The Proposed Network Rail (Essex and  
Others Level Crossing Reduction) Order  
Department for Transport Reference:  
TWA/17/APP/05

**Rebuttal of Susan Tilbrook's Proof of  
Evidence**

**OBJ/148/019 JNR Rebuttal**

Rebuttal of Susan Tilbrook's Transport Proof of Evidence

Closure T05 alternative proposed diversion route

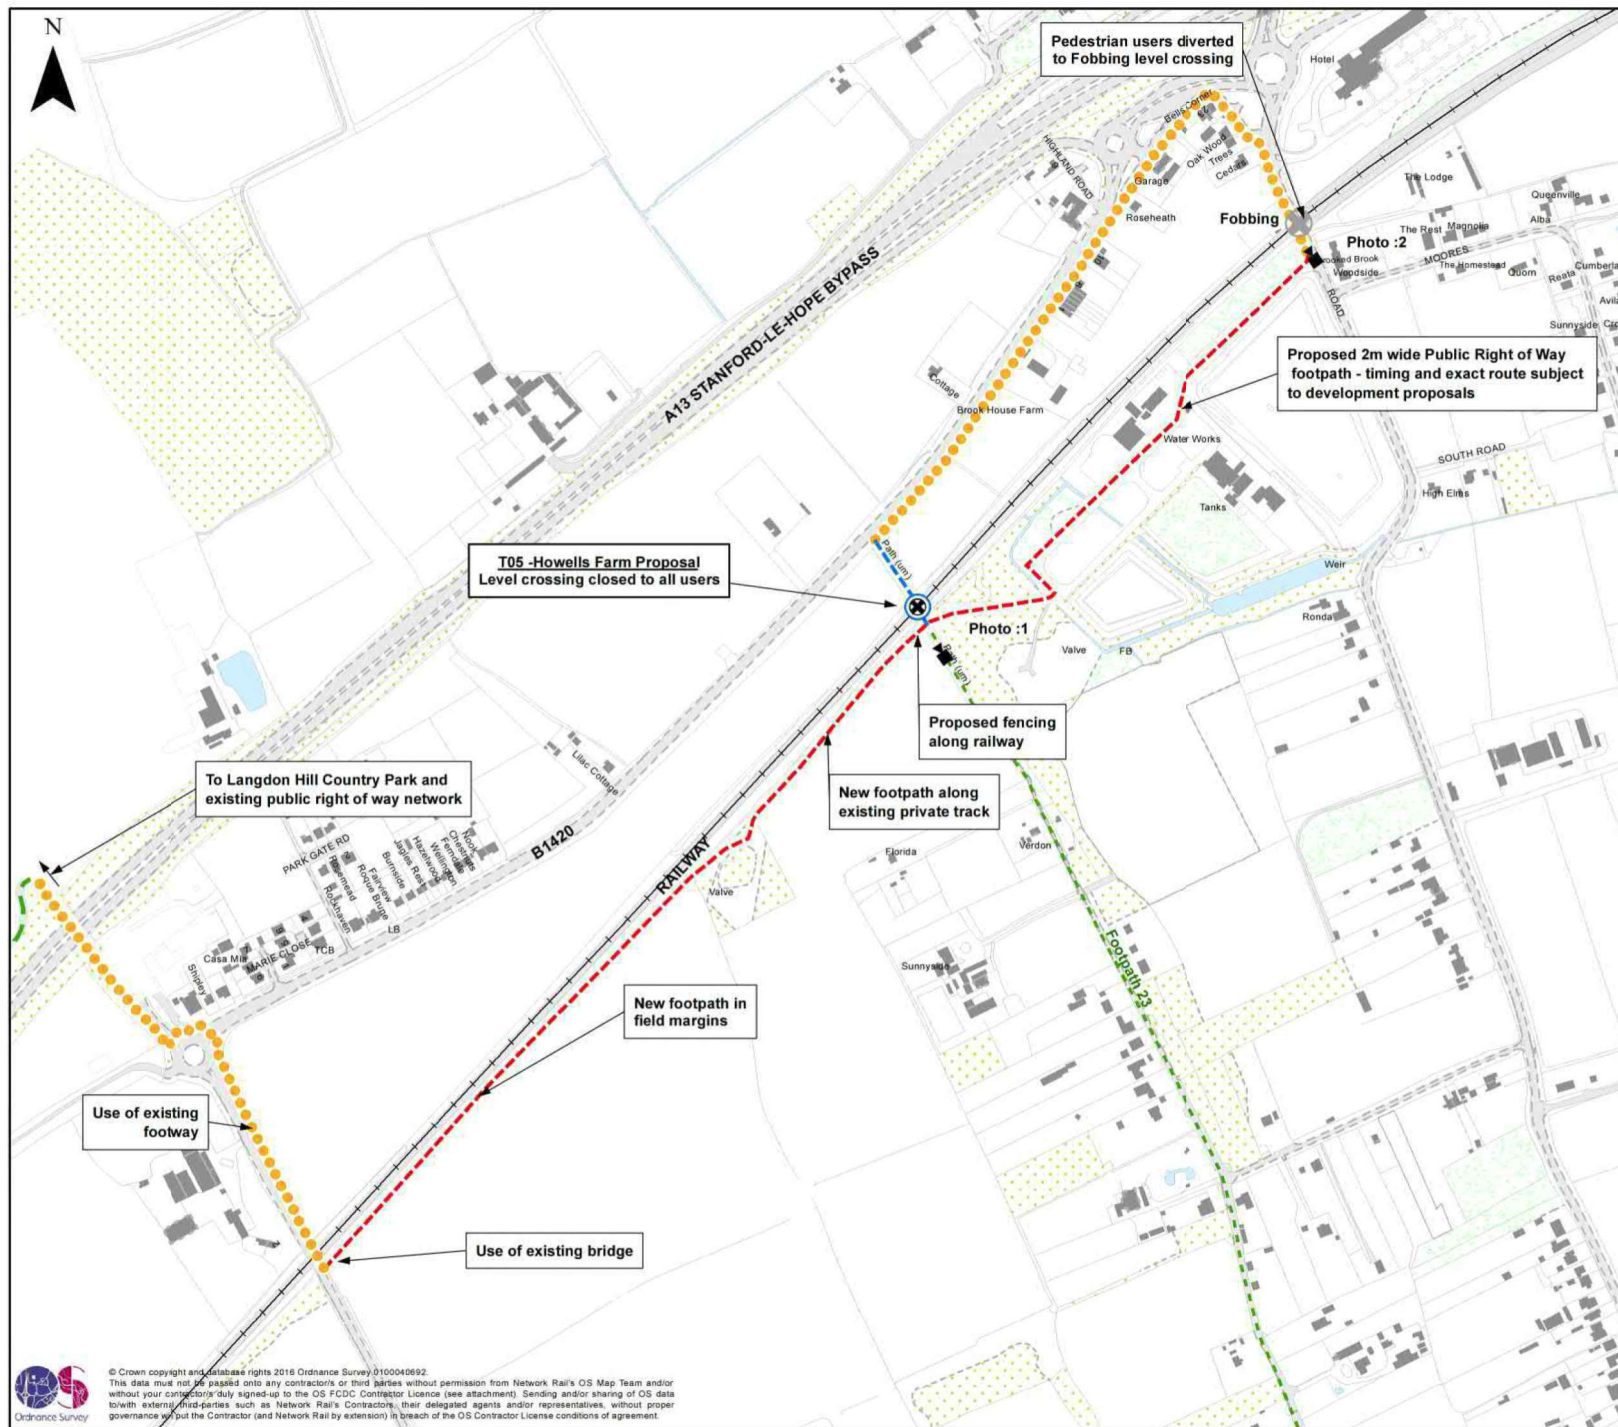
- 4.62 Since the submission of their Statement of Case, NR has provided a further proposed diversion route. This revised route is provided at my **Appendix B**.
- 4.63 I have not had the opportunity to audit this alternative route. I also note that ST confirms at paragraph 2.54.16 that a road safety audit has not yet been undertaken on the diversion route provided at my **Appendix B**.
- 4.64 On the basis of ST's acknowledgement of this, should the Inspector be minded to recommend that this closure be allowed subject to the provision of this alternative diversion route, I would invite the Inspector to defer a decision on this proposed closure until an RSA1 has been prepared and submitted for scrutiny with the RSA1 prepared with the benefit of traffic volume and speed data, collision data and NMU data rather than leaving assessment of this data for the stage 2 RSA.
